AIRWORTHINESS DIRECTIVE

Number: CAA-AD-065/2003
Supersedes CAA-AD-T-115/2001
Date of issue: July 18, 2003
Schweizer Aircraft Corp.
269A, 269A-1, 269B, 269C, TH-55A

HELICOPTER – CLUSTER FITTING – INSPECTION/REPLACEMENT

2003-13-15 Schweizer Aircraft Corporation: Amendment 39-13217. Docket No. 2002-SW-25-AD. Supersedes AD 2001-25-52, Amendment 39-12726, Docket No. 2001-SW-58-AD.

Figure 1

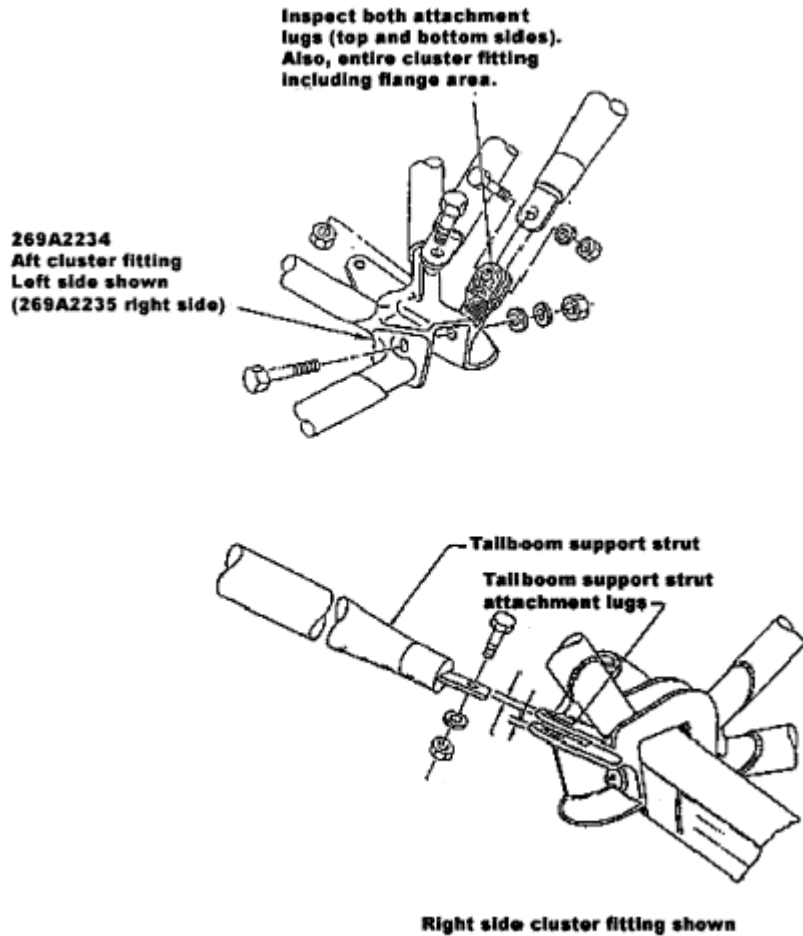
(1) Using paint remover, remove paint from the lugs on each cluster fitting. Wash with water and dry. The tailboom support strut must be removed prior to the paint stripping.

(2) Dye-penetrant inspect the lugs on each cluster fitting. See the following Figure 1:

(3) If a crack is found, before further flight, replace the cracked cluster fitting with an airworthy cluster fitting.
